WATER PERMIT NO. 1886-1

Application For Permit To Appropriate Water Within The State Of South Dakota

**RECOMMENDATION OF CHIEF ENGINEER FOR WATER PERMIT
APPLICATION NO. 1886-1, Homestake Mining of California**

REPORT ON APPLICATION NO. 1886-1

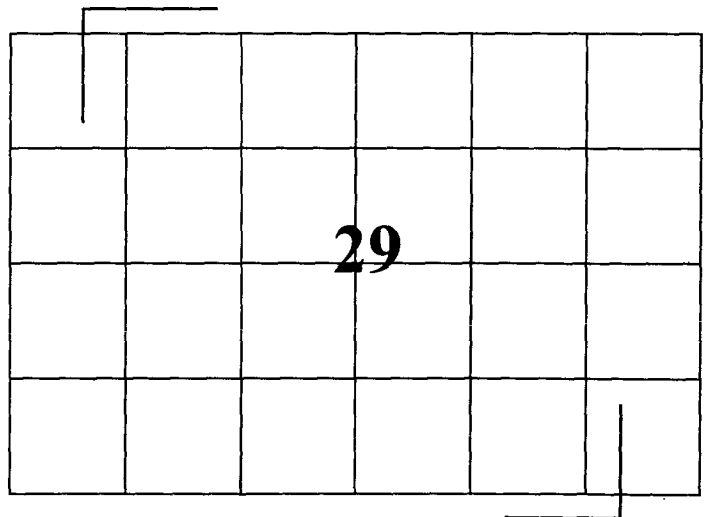
- Enclosed is the map submitted with the application. The map needs to reference a government section corner or quarter corner.
- Also, the map must be signed by one of the following: Registered Land Surveyor, Registered Professional Engineer or by any other government employee who normally prepares maps as a part of his assigned duties.

Enclosed is the revised map for the above-referenced application.
